No. 027

ExaCut

New Wear Parts

Re.: Cutting components 80° (major flow rate) and cutting components 45° (minor flow rate) of the ExaCut ECL24-40 and ECL18-40 series

Fig. 1

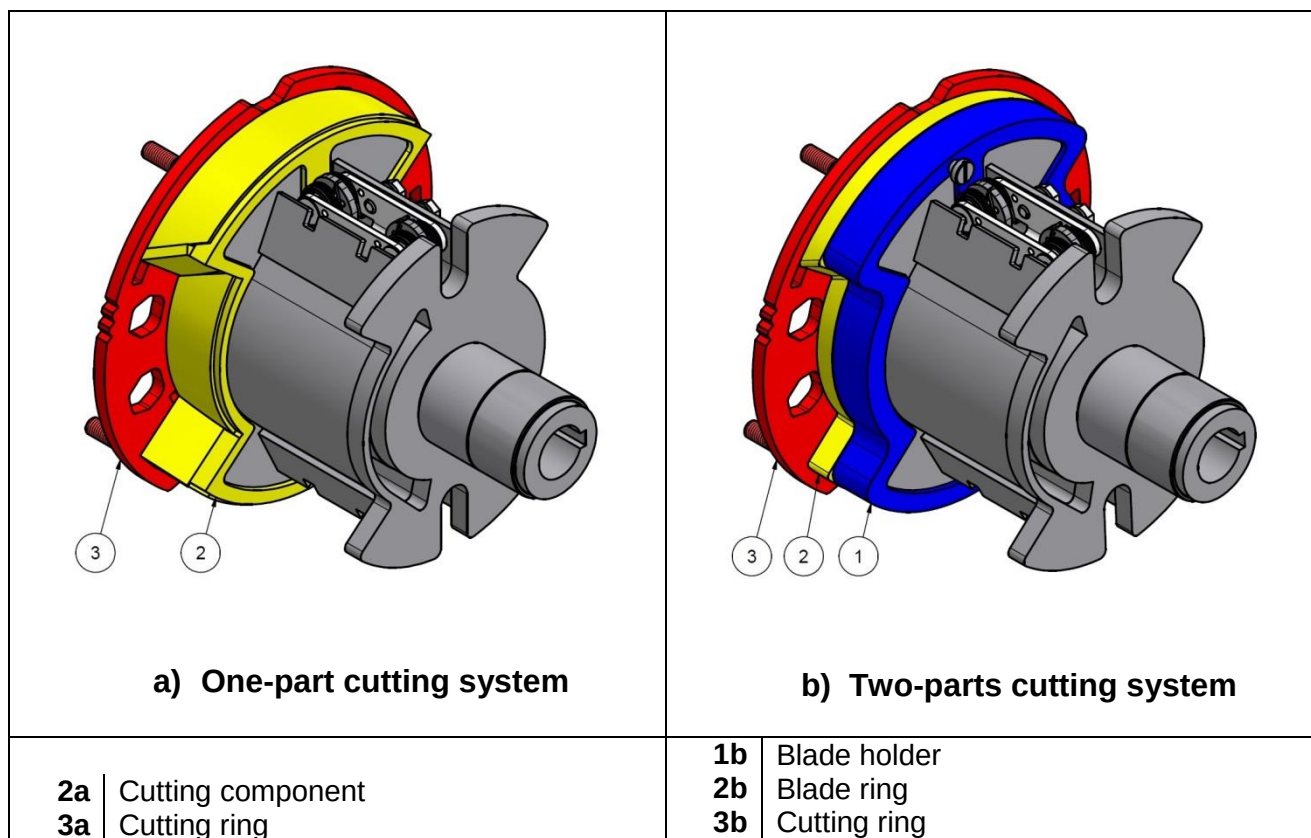
The cutting component used so far (see pos. 2, fig. 1 a) is being replaced by a combination of blade holder (pos. 1, fig. 1 b) and blade ring (pos. 2, fig. 1 b).

These two newly applied wear parts are compatible with the previously employed ExaCut versions of the series mentioned above.

One-part cutting system		Two-parts cutting system	
		1b	Blade holder 80° Part no. TMH0021
		1b	Blade holder 45° Part no. TMH0024
2a	Cutting component 80° Part no. TMH.503	2b	Blade ring 80° Part no. TMS0051
2a	Cutting component 45° Part no. TMH.505	2b	Blade ring 45° Part no. TMS0053

Fig. 2

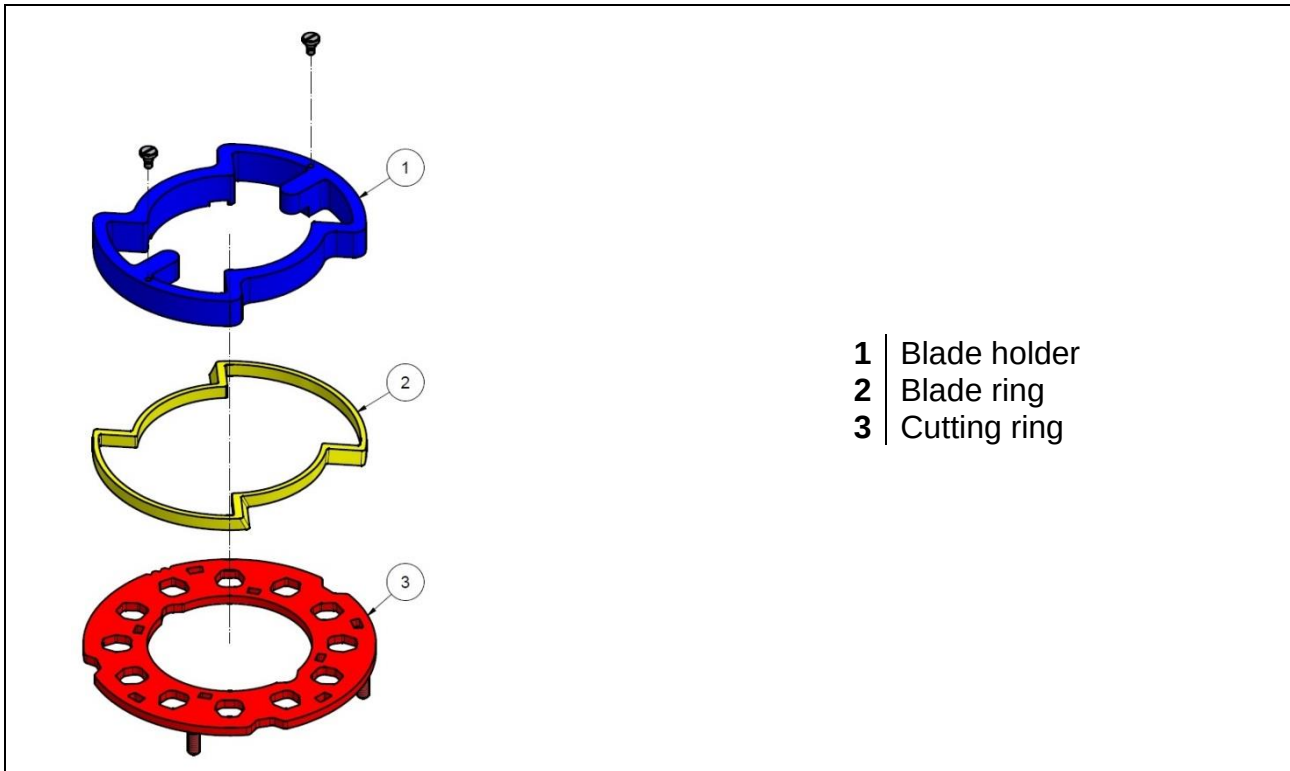
In case wear-parts' repair is needed in future, only the blade ring and the cutting ring (pos. 3) need to be replaced (fig. 1 and 2).

Fig. 3

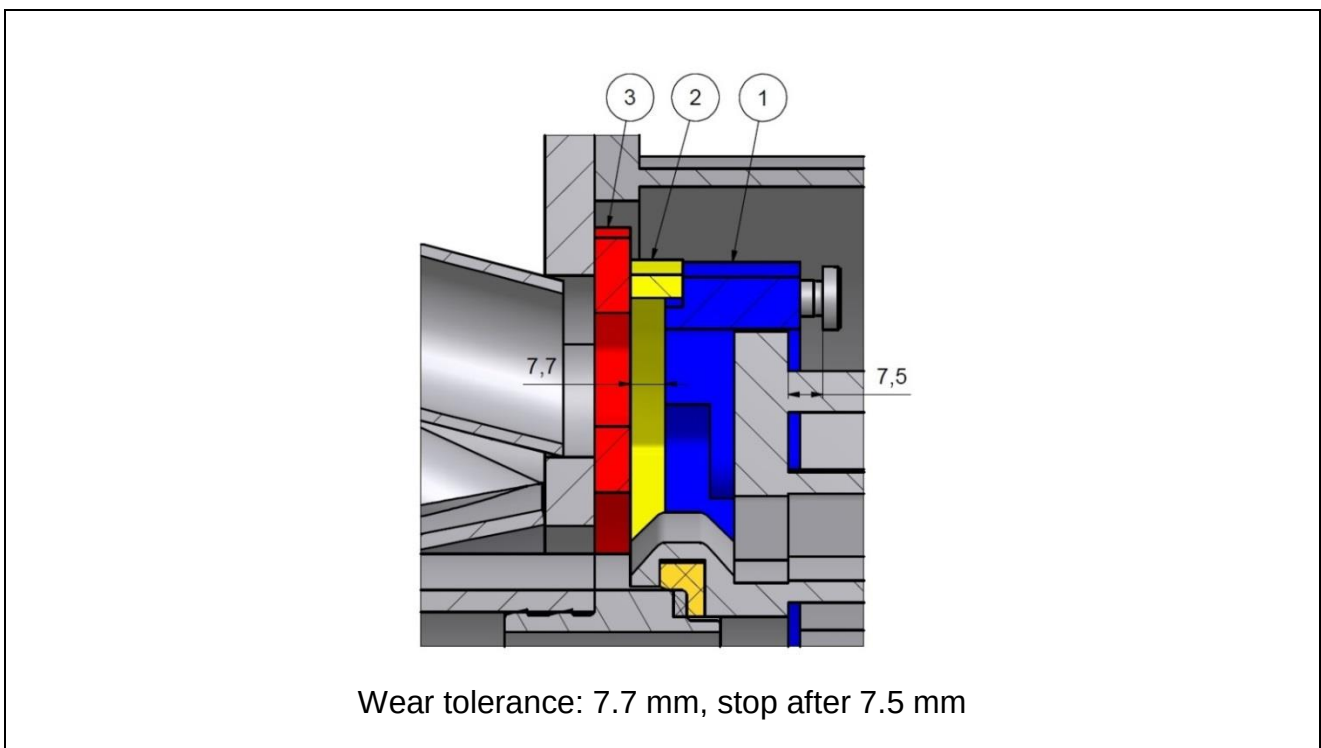
The blade holder (1) is equipped with a locking screw (see fig. 3), preventing it from coming in contact with the cutting ring (3).
